Rezoning Transportation Analysis

Petition Number: 2019-085
General Location Identifier: 20145105

Date	Description
07-17-2019	First Review (EL)
09-24-2019	Second Review (EL)
10-22-2019	Third Review (EL)
12-23-2019	Fourth Review (EL)
09-21-2020	Fifth Review (KP)
11-10-2020	Sixth Review (KP)

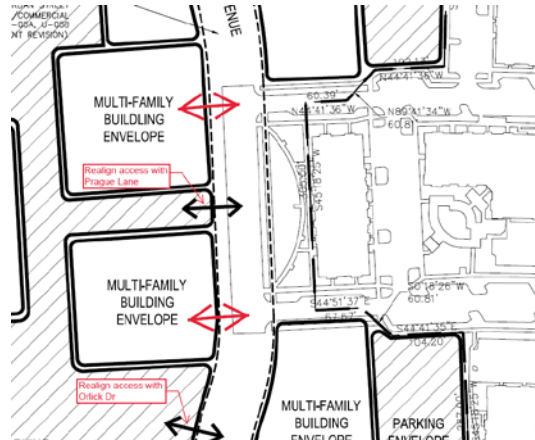
4. ~~**Steele Creek Area Plan**~~
 - a. ~~The petitioner should revise the site plan and conditional note(s) to commit to construct an 8-foot planting strip, and 6-foot sidewalk on Arrowood Rd, per the Steele Creek Area Plan. CDOT requests for the back of 6-foot sidewalk to be placed 53 feet from centerline, to plan for a future 12-foot multi-use path. The site plan should label and dimension both items from the back of curb and gutter/road centerline.~~
 - b. ~~**Comment Revised/Outstanding** The petitioner should revise the site plan and conditional note(s) to construct the future Arrowood Road/Whitehall Park Drive Connection to the intersection of the Savoy Corporate Drive's future extension alignment, per the Avenue – Two Lane Undivided cross section provided within the Steele Creek Area Plan.~~
